**Before Independent Hearing Commissioners
In Ngāruawāhia**

In the matter of of a submission by Ambury Properties Limited in respect of the proposed Waikato District Plan pursuant to Clause 6 of Schedule 1 of the Act seeking the rezoning of land at Ohinewai

**Summary statement of evidence of Robert Swears for Waka Kotahi –
Transportation Engineering**

9 September 2020

Figure 3.2: Safe intersection sight distance (SISD)

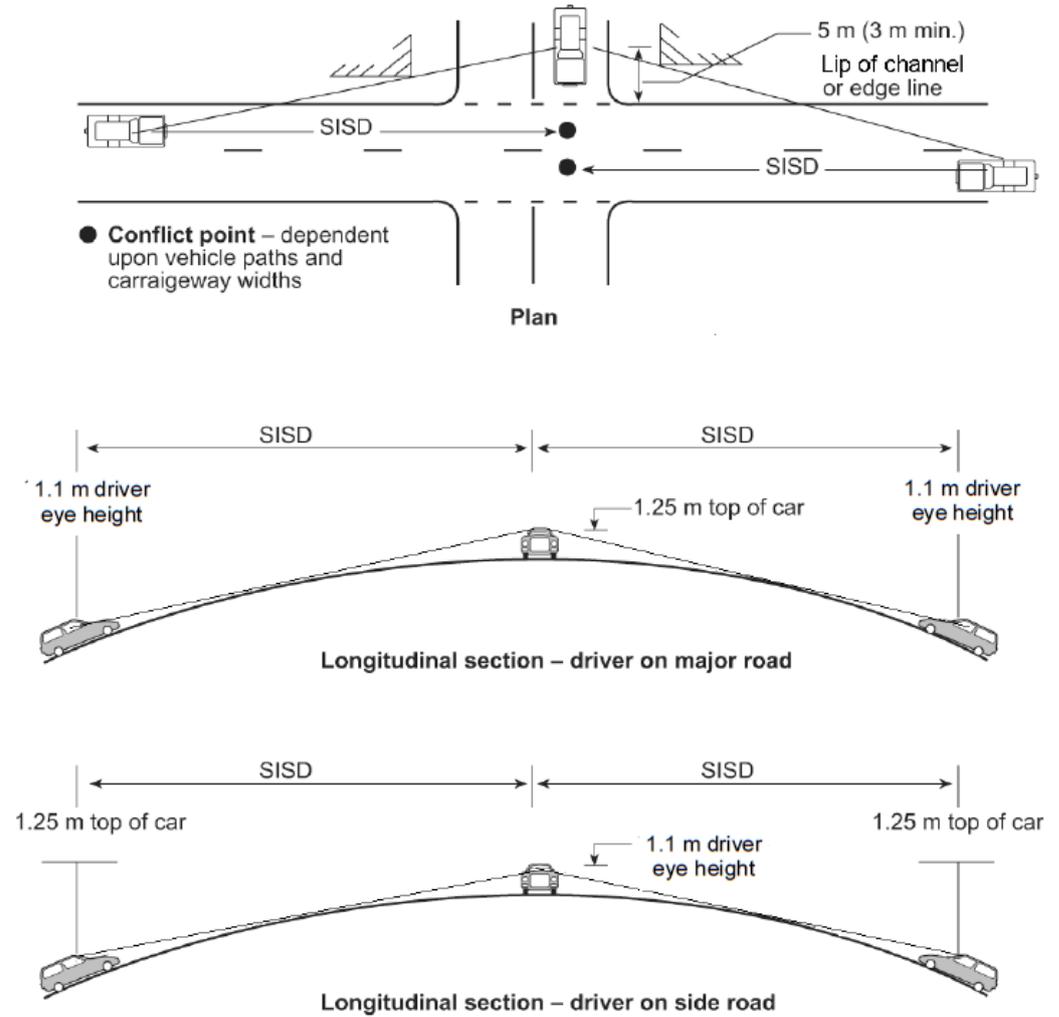
Interchange		
<p>6. Sight distance from southbound off-ramp is inadequate.</p>	<p>Ensure reduced operating speeds on Tahuna Road or widen NIMT overbridge and remove vertical sag curve between overbridge and Tahuna / Lumsden roundabout.</p>	<p>Mr Inder has referred⁸ to MegaMaps in relation to safe and appropriate speeds on the road network in the vicinity of the Site. However, MegaMaps has been updated recently⁹ and some of the speed limits to which he refers have changed. For example:</p> <ul style="list-style-type: none"> • Southbound off-ramp - 100 km/h rather than 60 km/h. • Tahuna Road across interchange - 60 km/h rather than 80 km/h. • Ohinewai Road South - 80 km/h rather than 60 km/h. <p>There presently is no certainty regarding the speed limit or the operating speed on Tahuna Road at the Interchange. However, I accept Mr Inder's observation¹⁰ that the vehicle movements associated with the Proposal are most likely to be turning left from the southbound off-ramp and therefore the sight distance to the right is most important; that sight distance is greater than the sight distance to the left. However, I have not changed my view that the sight distance to the left is inadequate and the adequacy of the sight distance to the right is very dependent on operating speeds on Tahuna Road and on minimum criteria being adopted for the position from which sight distances are measured.¹¹</p>
